DEVELOPMENT APPLICATION ASSESSMENT REPORT

Application Number:	DA2022/1945
----------------------------	-------------

Responsible Officer:	Gareth David
Land to be developed (Address):	Lot 7 DP 205199, 13 Carolyn Avenue BEACON HILL NSW 2100
Proposed Development:	Alterations and additions to a dwelling house
Zoning:	Warringah LEP2011 - Land zoned R2 Low Density Residential
Development Permissible:	Yes
Existing Use Rights:	No
Consent Authority:	Northern Beaches Council
Land and Environment Court Action:	No
Owner:	Robyn Helen Maiolo
Applicant:	Kubanyi Architects

Figure 1 - Proposed height variation (in blue)

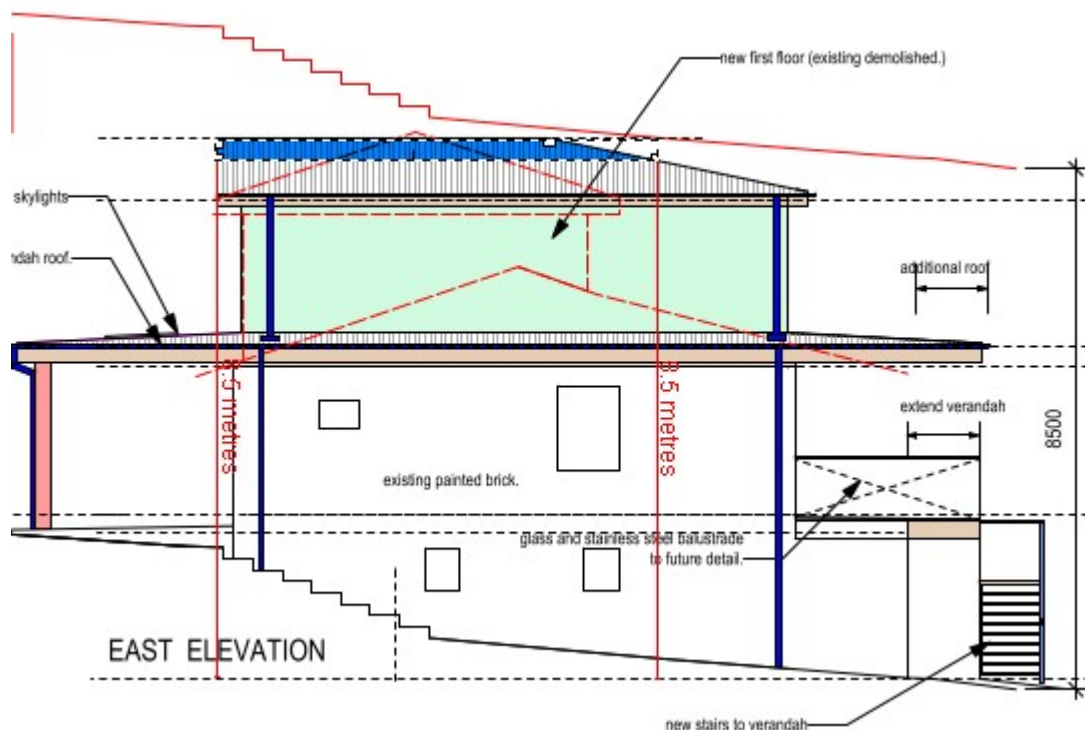
The maximum height of the proposed development has been measured at 8.8m from existing excavated (garage) level. This represents a variation of 3.5%. The height breach is limited to a minor portion of the proposed roof form.

Figure 1 and 2 below demonstrates the extent of the exiting height breach (highlighted in blue):

Figure 1: Side boundary envelope breach of proposed additions on the western elevation shown in red.

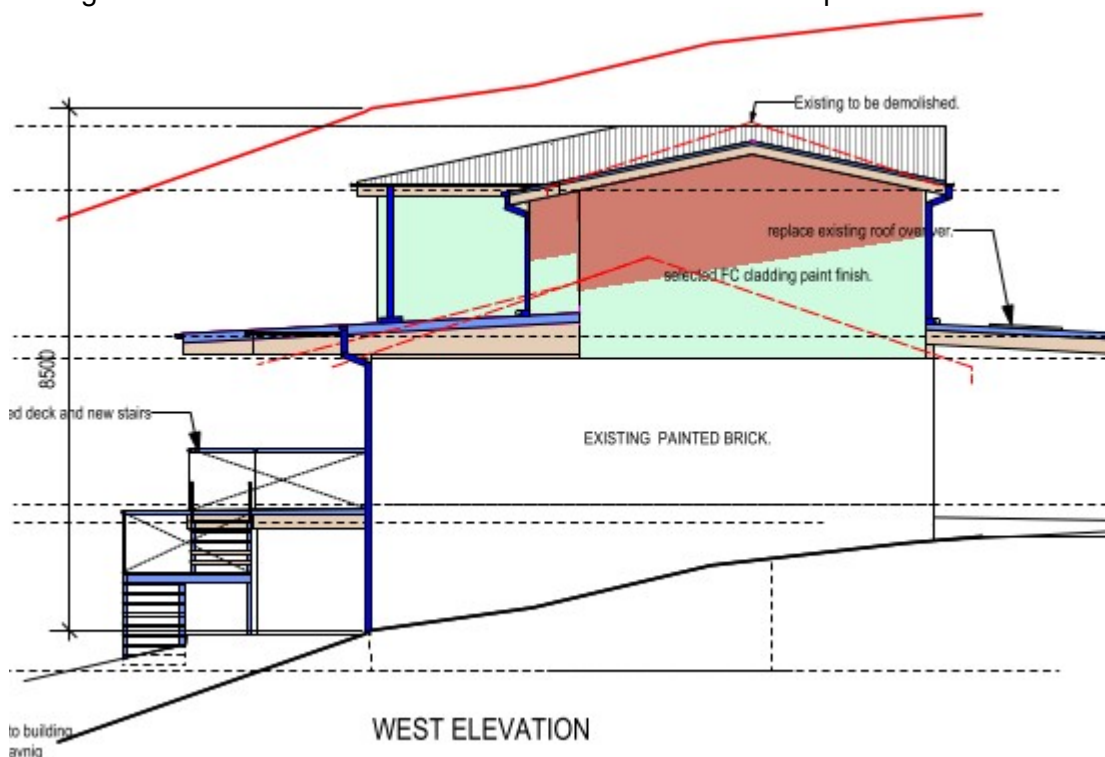
The figures below show the location and extent of the non-compliance.

Note this would largely replace an existing non-compliance*
